Re: Construction of a porch extension to the front elevation. Conversion of the attached tandem-length garage to provide a garden room/gym. Construction of a dormer on the front elevation to serve the existing Bedroom. Alterations to the existing fenestration to include a first floor balcony to the rear with glazed balustrading and new doors for access, a dummy pitched roof to the garage, and replacement external doors to the rear elevation. Minor Internal alterations at first floor level to increase size of existing bedroom. Creation of a Juliet balcony at second floor level. Minor hard and soft landscaping works adjacent to the front porch and rear of the garage.

6 Glendale Road, Burgess Hill, West Sussex RH15 0EJ

Application Reference: DM/26/1479

Figure 1: The proposed balcony, “walk-on rooflight” and balustrading area is denoted by the red line.

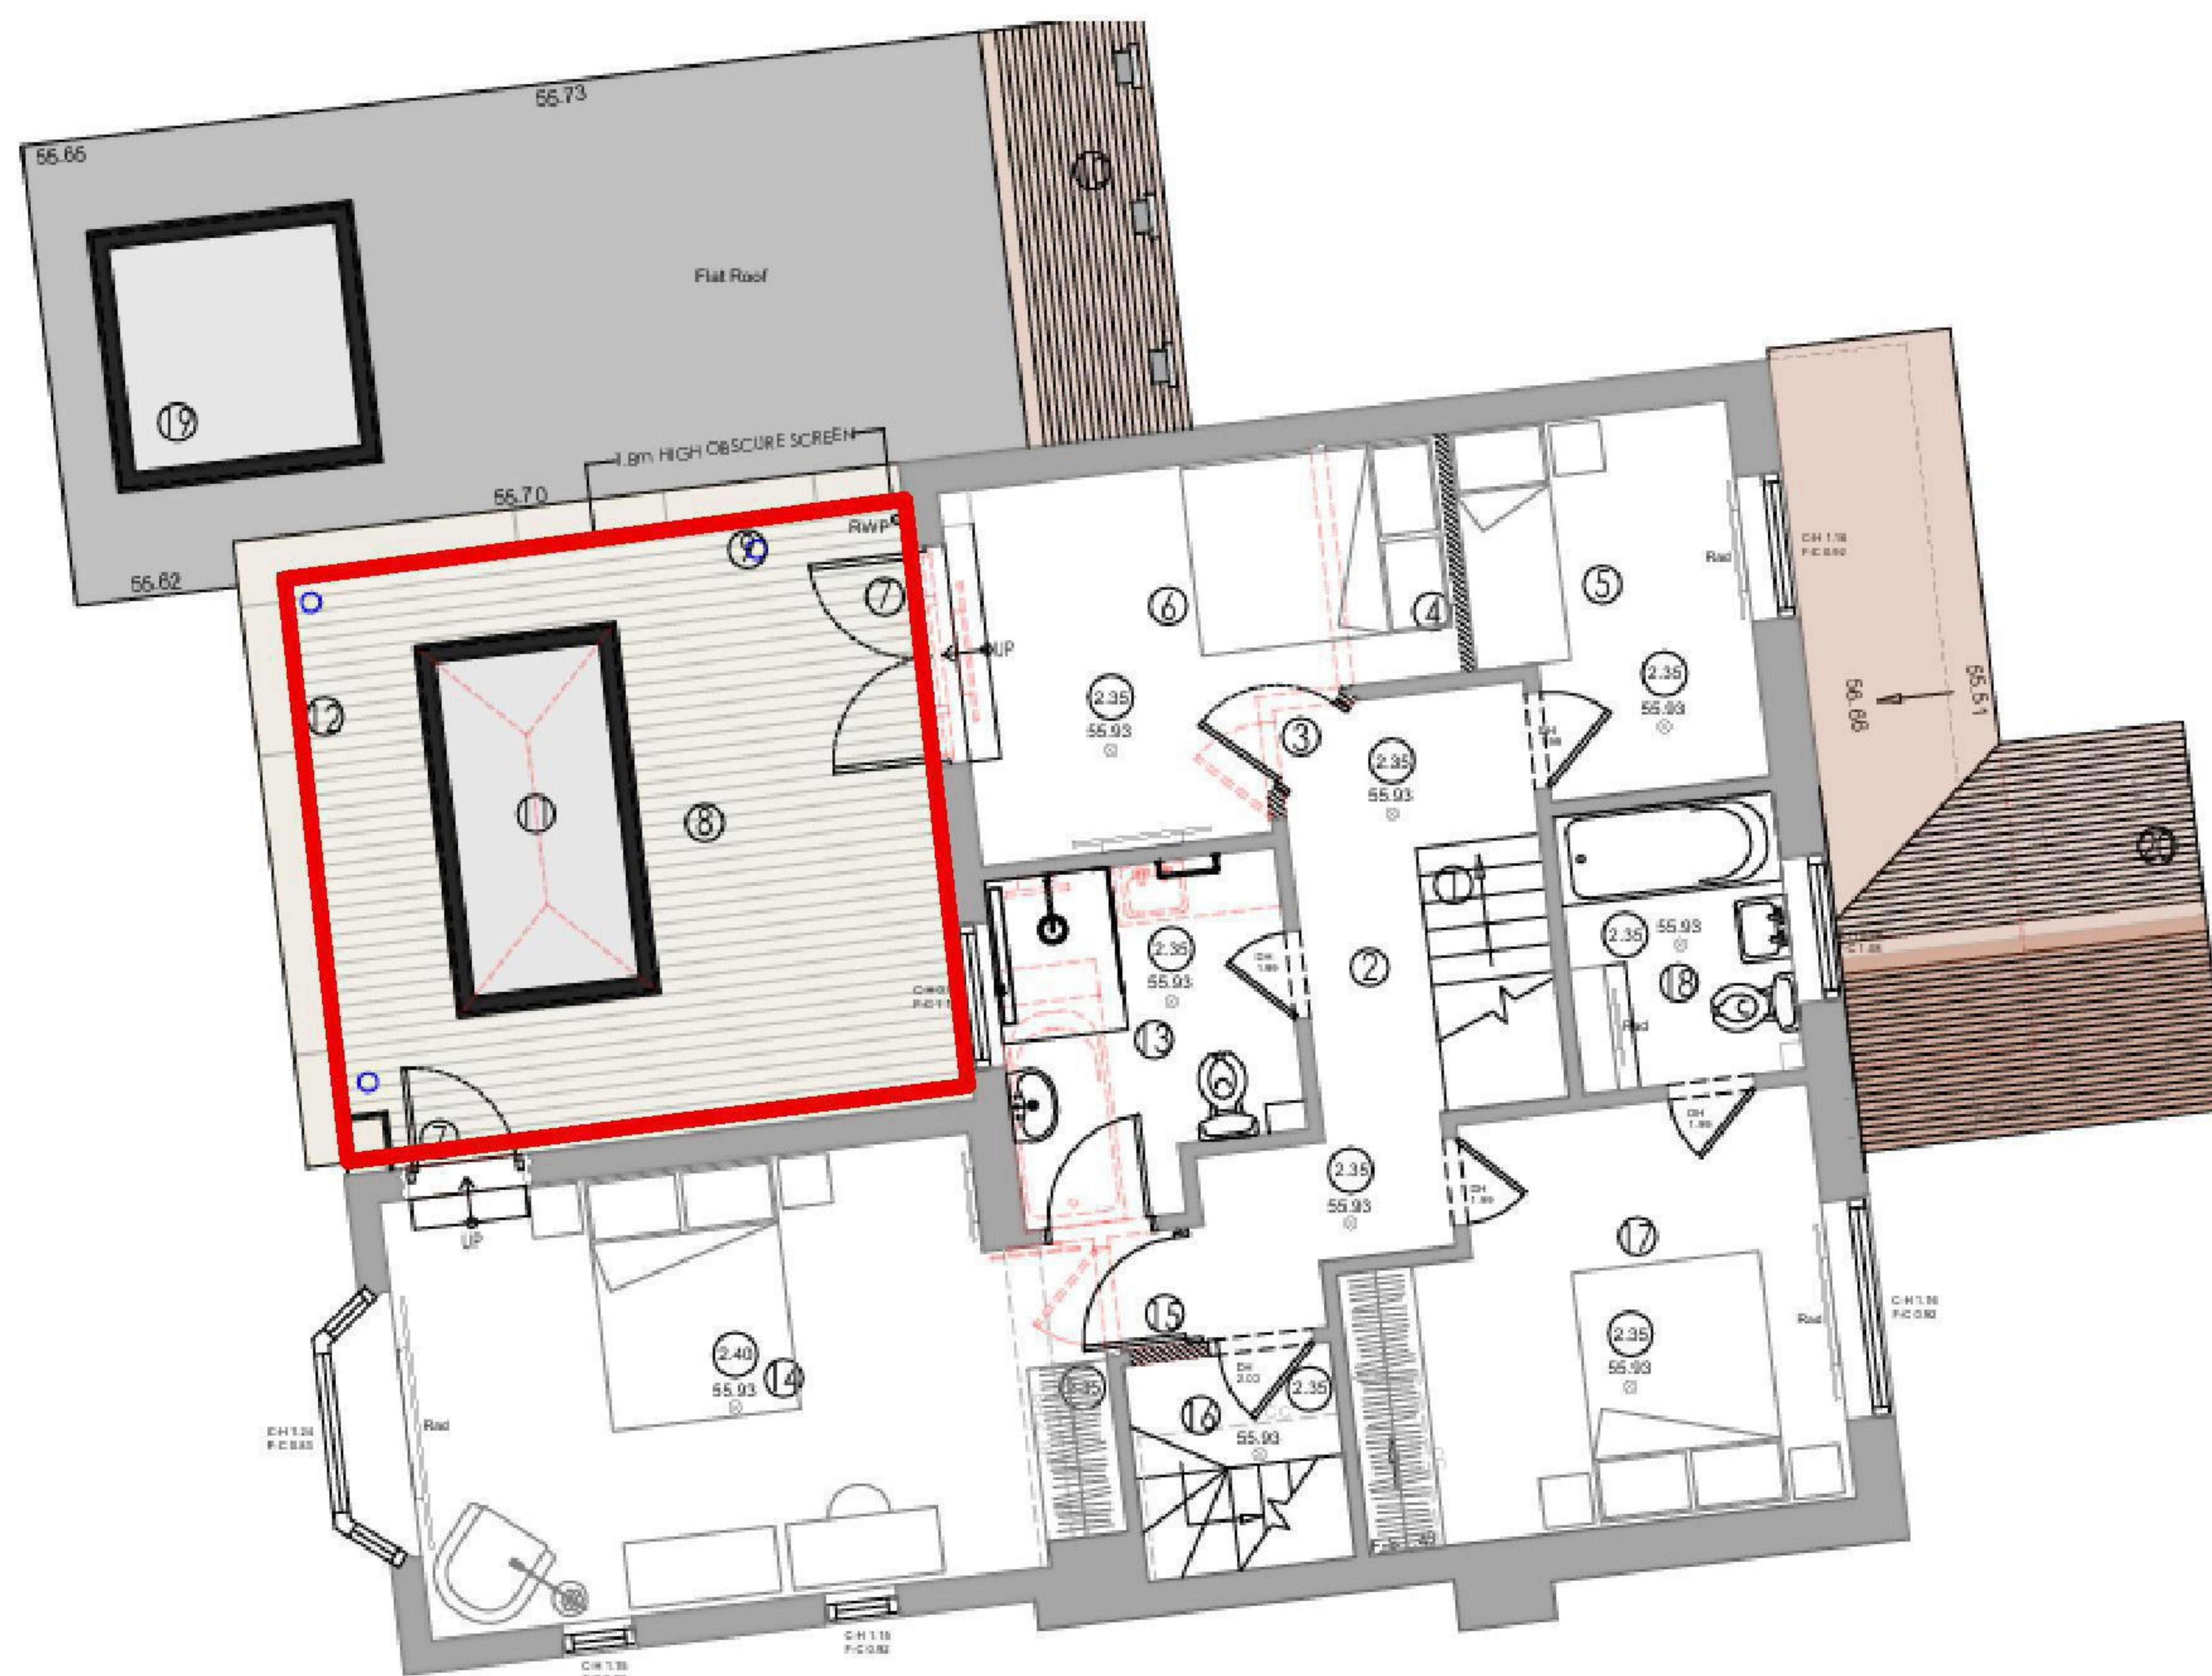
The application proposes the formation of a first-floor balcony to the rear of the dwelling, together with new doors to provide access to it, formed over the flat roof of the existing single-storey element. The First Floor General Arrangement (drawing PL.003) identifies the balcony, a “walk-on rooflight” and balustrading:

The submitted elevations record a ground floor finished floor level of 53.34m AOD and a first-floor finished floor level of 55.93m AOD. The deck of the proposed balcony would therefore sit some 2.59m above the ground floor level of the host dwelling, and materially above the 1.8m composite panel on the shared boundary. That existing fence would provide no meaningful screening whatsoever from an elevated platform at this height.

The consequence is that the proposal would introduce a new, elevated, external amenity area capable of active and sustained use, in a position that directly overlooks 4 Glendale Road. The resulting overlooking would be of materially different to that arising from a first-floor window. A balcony is used for prolonged periods, at all hours, and in a manner that permits the user to move about and to look outwards and downwards across the boundary. It gives rise both to actual overlooking and to a perception of being overlooked, and the latter is itself capable of amounting to an unacceptable loss of amenity in this case.

The applicant recognises that the proposal gives rise to an overlooking issue. The Key provided on drawing PL.003 describes a *"1.8m high frosted glass balustrade to prevent overlooking"*, and the North Elevation on drawing PL.005 is annotated as a *"1.8m high obscure screen"*. This proposed mitigation is considered an admission of harm rather than a remedy, and it is inadequate for the following reasons:

- The screen is a fragile and impermanent form of mitigation. Obscure glazing and screens are liable to be damaged, removed, replaced or simply not maintained, and the Council would be reliant on enforcement action to secure a benefit upon which the amenity of the School's tenants would depend in perpetuity.
- The extent of the screening is not clearly defined across the submitted drawings, and it is not evident that it would enclose the full northern and north-western flanks of the balcony. Oblique views across the shared boundary would remain.

- The permanent retention of obscure screening to the northern and north-western flanks of the balcony at a minimum height of 1.8m above finished deck level, to be installed prior to first use of the balcony and thereafter retained in perpetuity, and for the exact details of the obscure glazing to be secured via planning condition;
- The submission and approval of a scheme of acoustic insulation to the northern flank wall and roof of the proposed garden room/gym, to be implemented in full prior to first use and thereafter retained;
- A restriction limiting the use of the garden room/gym to purposes ancillary and incidental to the enjoyment of the dwellinghouse at 6 Glendale Road, precluding any commercial or business use;
- A restriction on the hours of use of the garden room/gym and of the first-floor balcony; and
